Name Of Dam: EMBRY DAM
Location: STAFFORD COUNTY, VA
Inventory Number: VA 17905

PHASE I INSPECTION REPORT

NATIONAL DAM SAFETY PROGRAM

Embry Dam (VA-17905). Rappahannock River
Basin. Stafford County, Virginia.
Phase I Inspection
Report.

**APPROXIMATE SECTION THRU
PRESENT DAM**
SCALE: 1/4" = 1'-0"

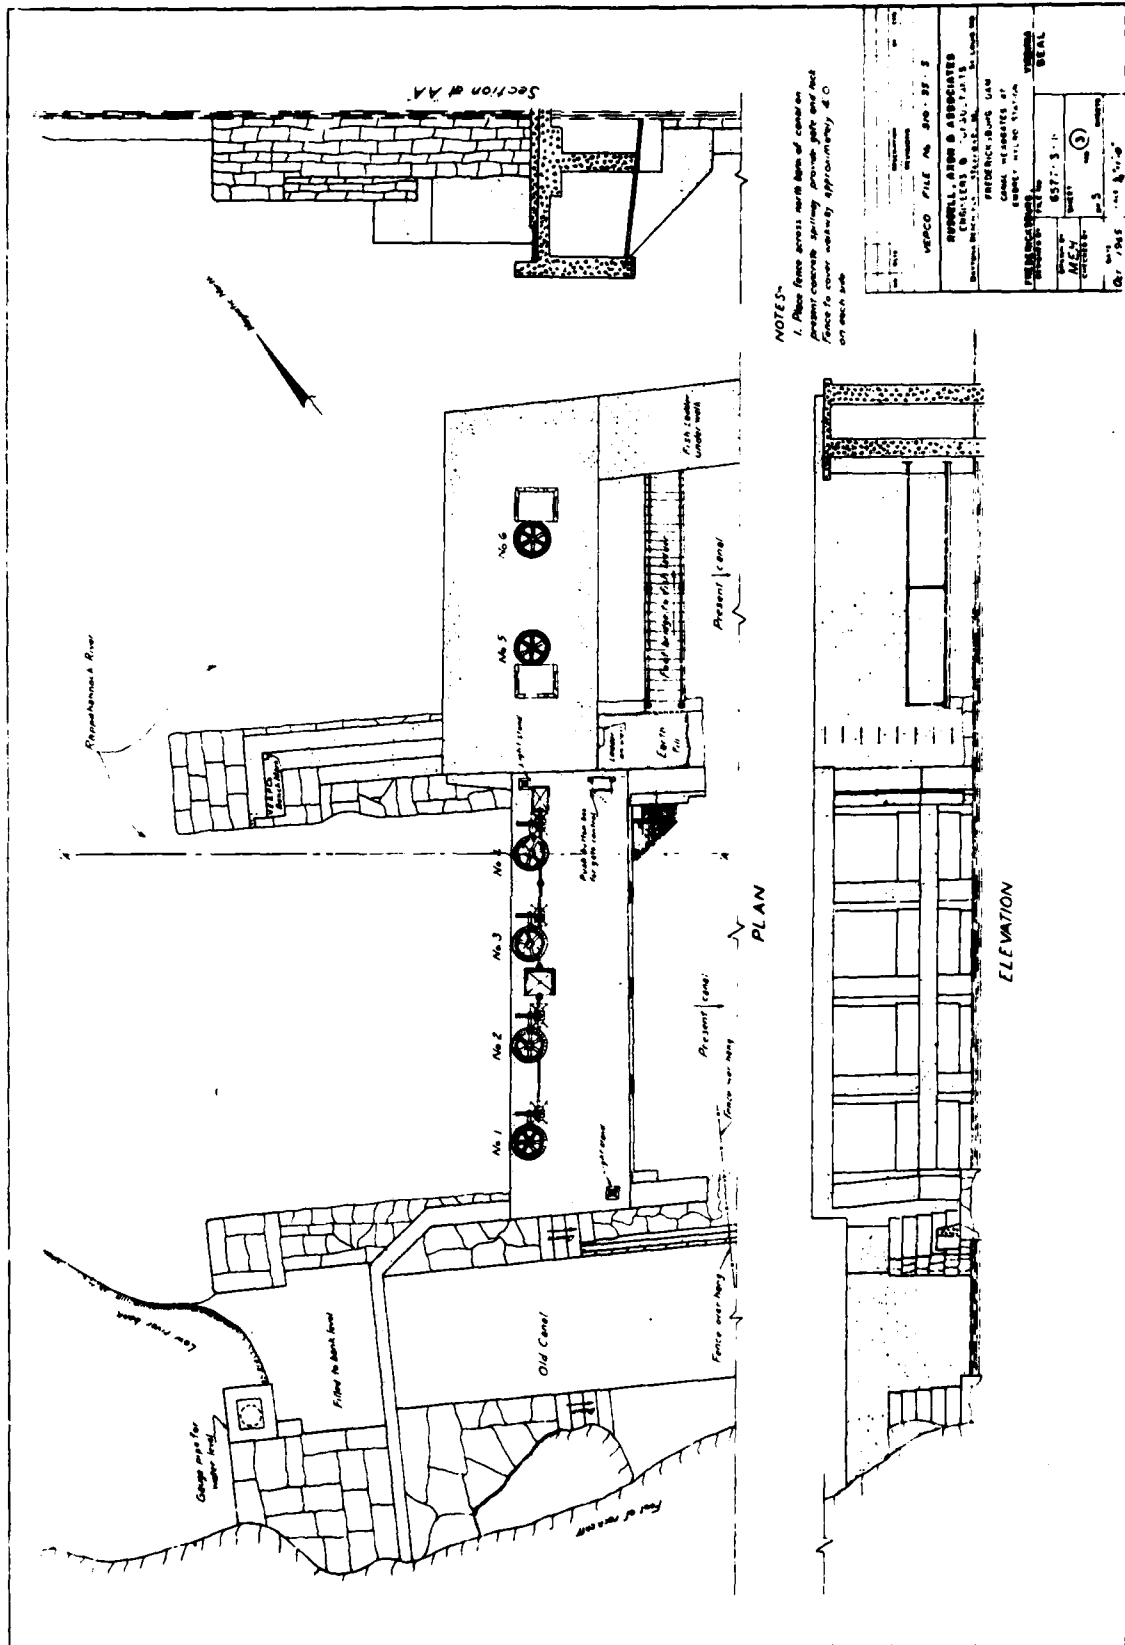
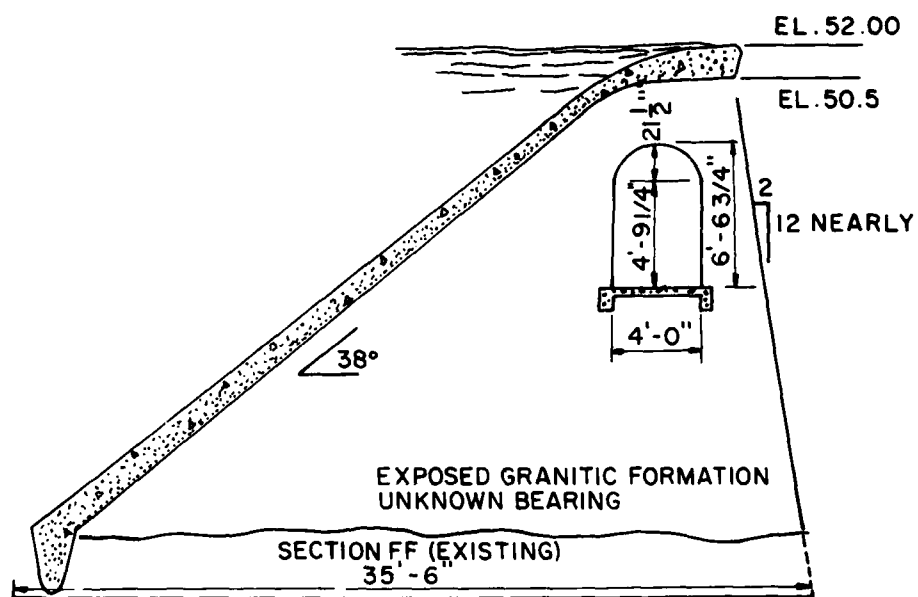
2.3 Evaluation: The available drawing prepared by Russell and Axon is adequate to perform general stability/overturning analysis, however, information is not detailed enough to properly assess cracking in the slabs. See paragraph 7.2 Recommended Remedial Measures for additional engineering study recommended.

6.3 Evaluation: Since construction reports are not available for review, a proper determination of the foundation conditions is not possible. Plate 2, however, shows that the dam is founded on granite.

7.2.1 The owner, through his professional engineers, should immediately investigate the ability of the existing slab to carry imposed loads up to and including the 1/2 PMF. This can be accomplished by measuring the size and spacing of exposed reinforcing steel. Calculations should be performed using a reduced cross sectional area of steel where appropriate. To evaluate concrete strength, cores should be taken and analyzed for strength and durability. Soundings should be taken to determine the extent of siltation on the dam. Silt loads should be included during analysis of slabs. Portions of the dam not inspected between buttresses 21 and 43, should be inspected. Additional study or repair indicated by this inspection should be accomplished as appropriate.
